ADDENDUM NO. 1

**PROJECT: 2024 Curb Installation and Replacement Contract
Village of Hastings-on-Hudson**

Contractors bidding the referenced project are advised of the following revisions to the Bid Documents.

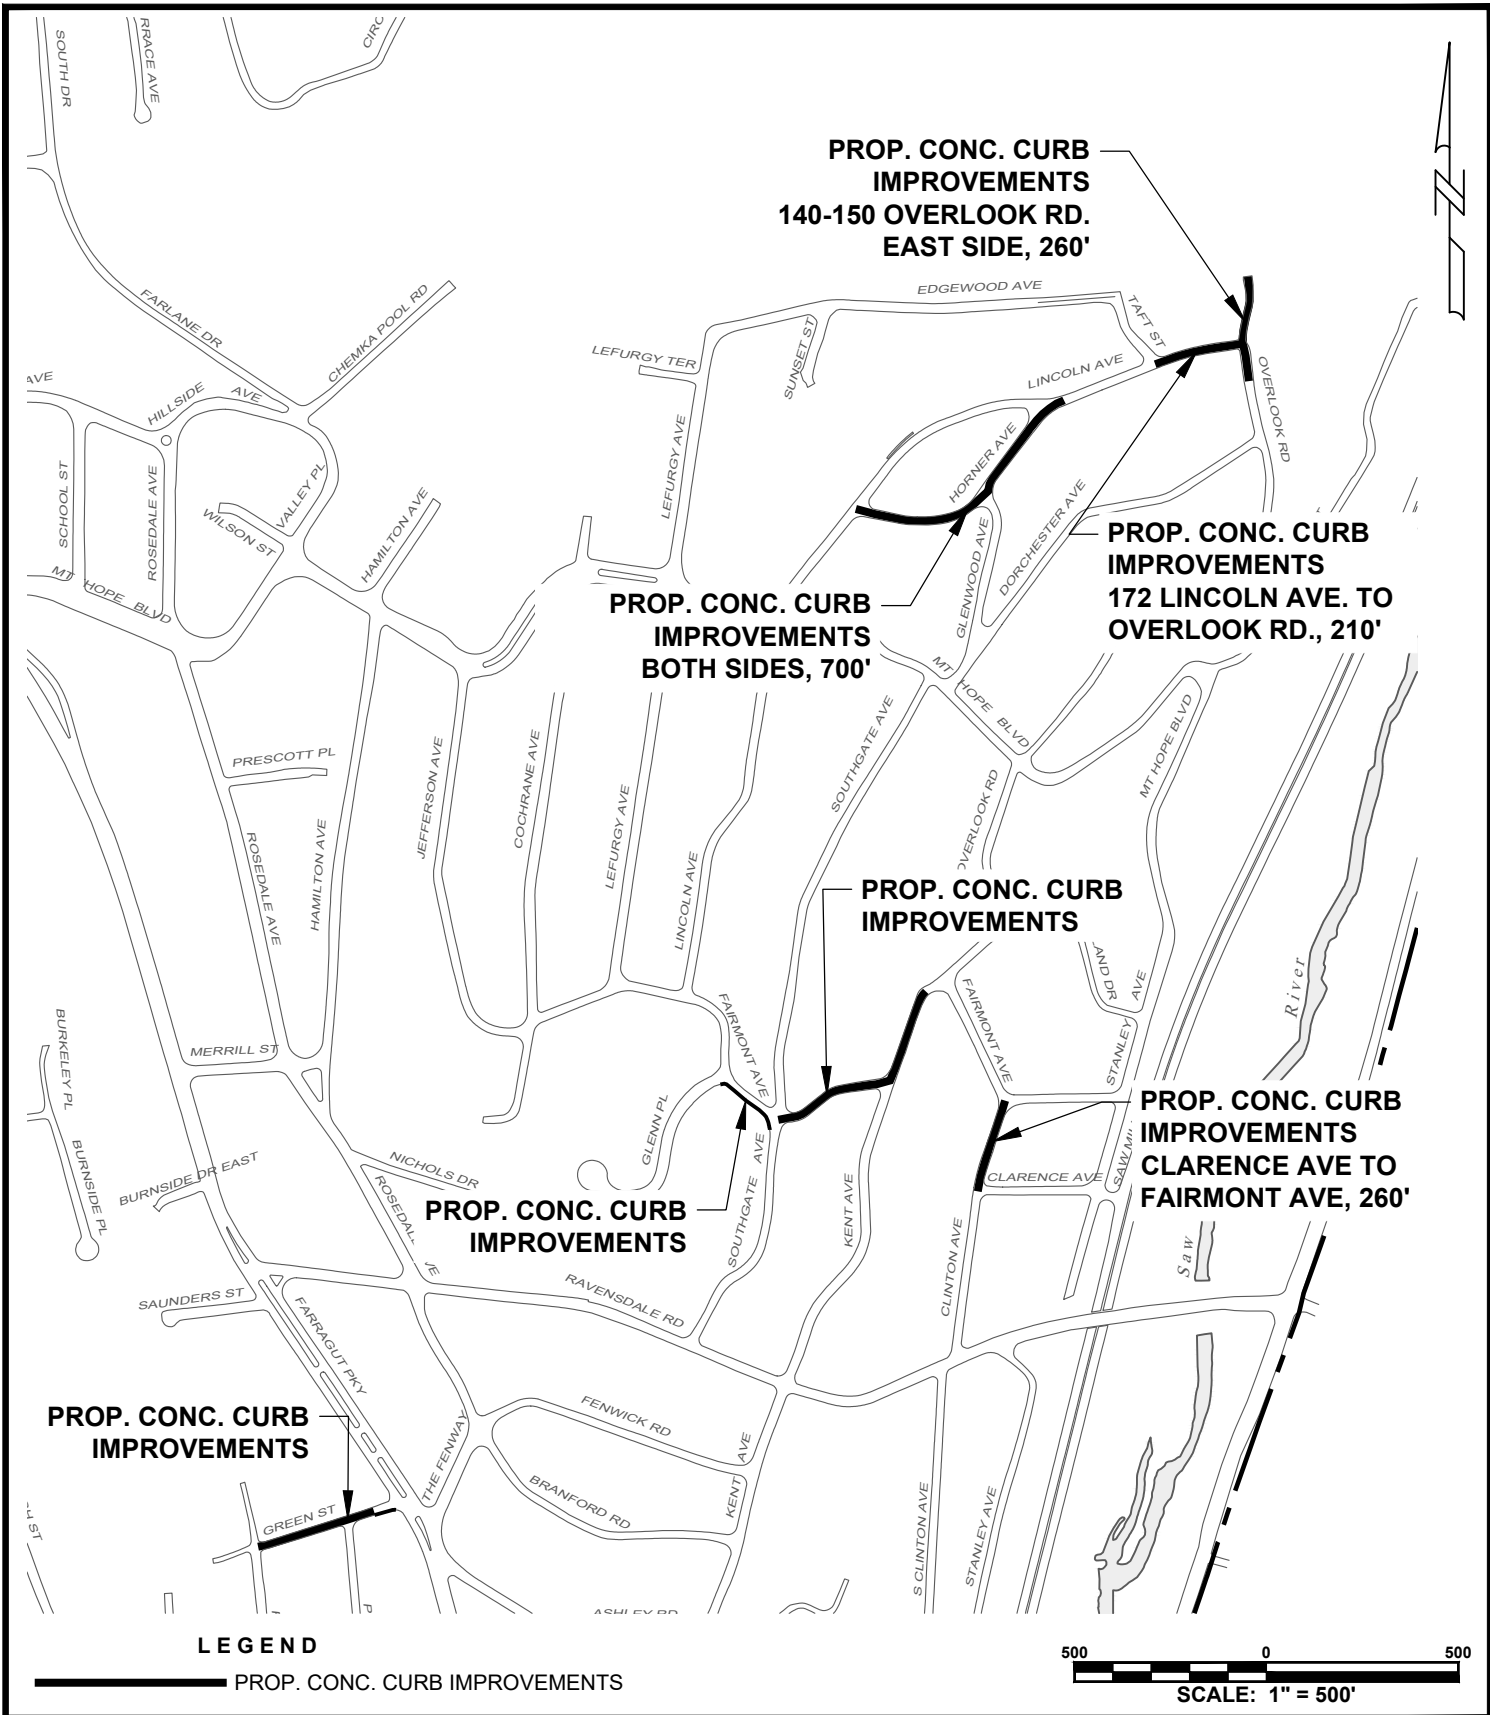
- 7) The Curbs Location Plan for the Village of Hastings-on-Hudson has been revised, see attached Curbs Location Plan.
- 8) **REMOVE** the individual quantities summary sheet in Appendix B for the Village of Hastings-on-Hudson and **INSERT** the revised individual quantities summary sheet for the Village of Hastings-on-Hudson attached.

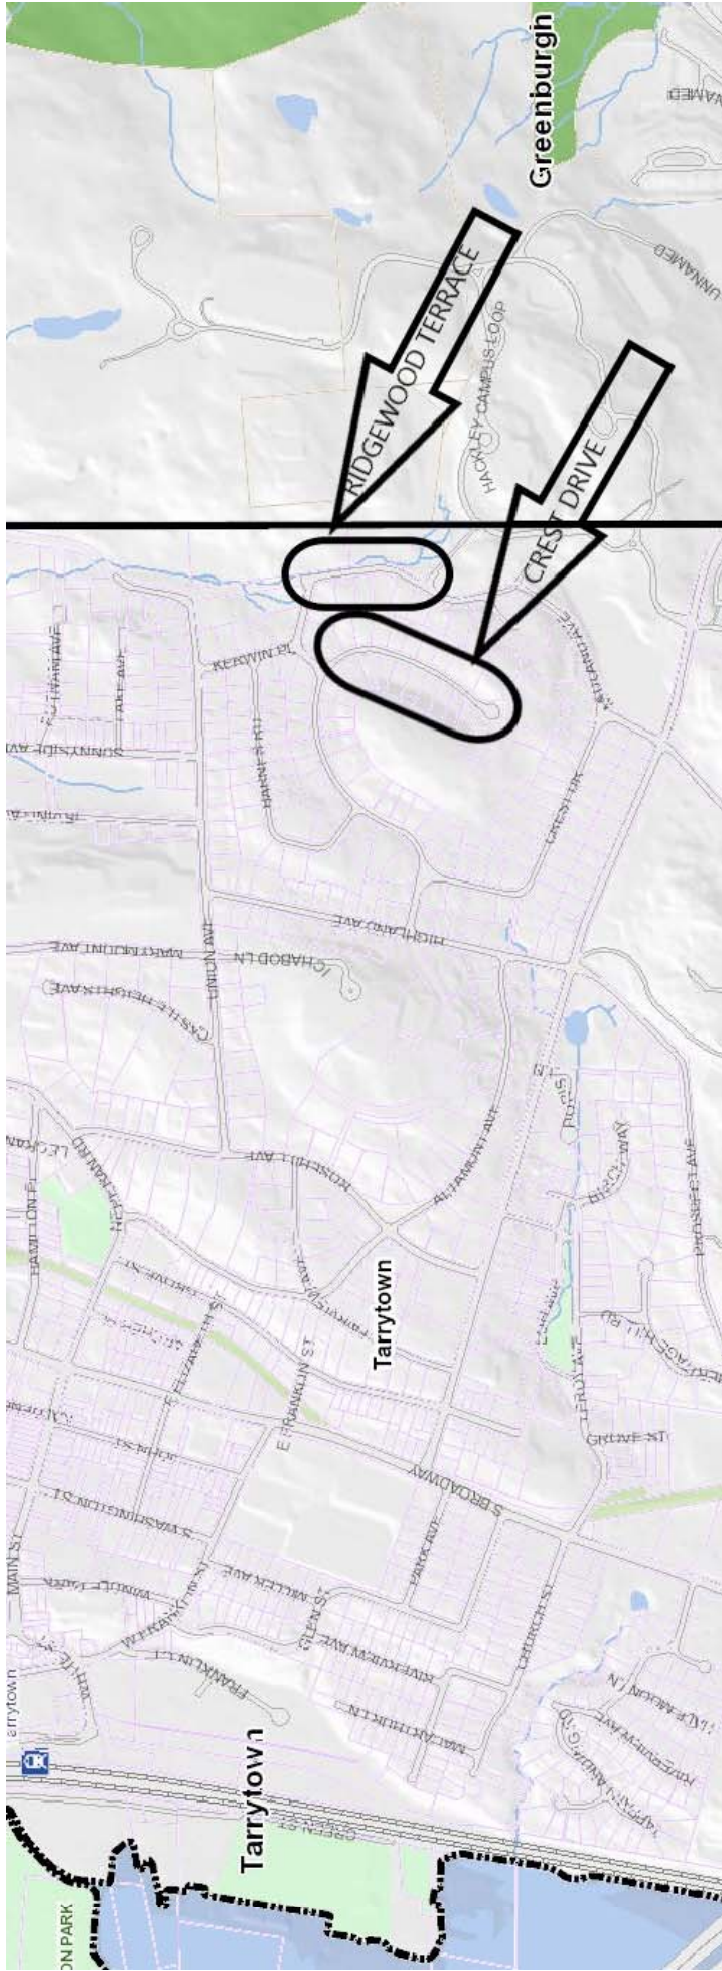
- 9) A location map for curbs throughout the Village of Tarrytown has been attached.
- 10) **REMOVE** the individual quantities summary sheet in Appendix B for the Village of Tarrytown and **INSERT** the revised individual quantities summary sheet for the Village of Tarrytown.
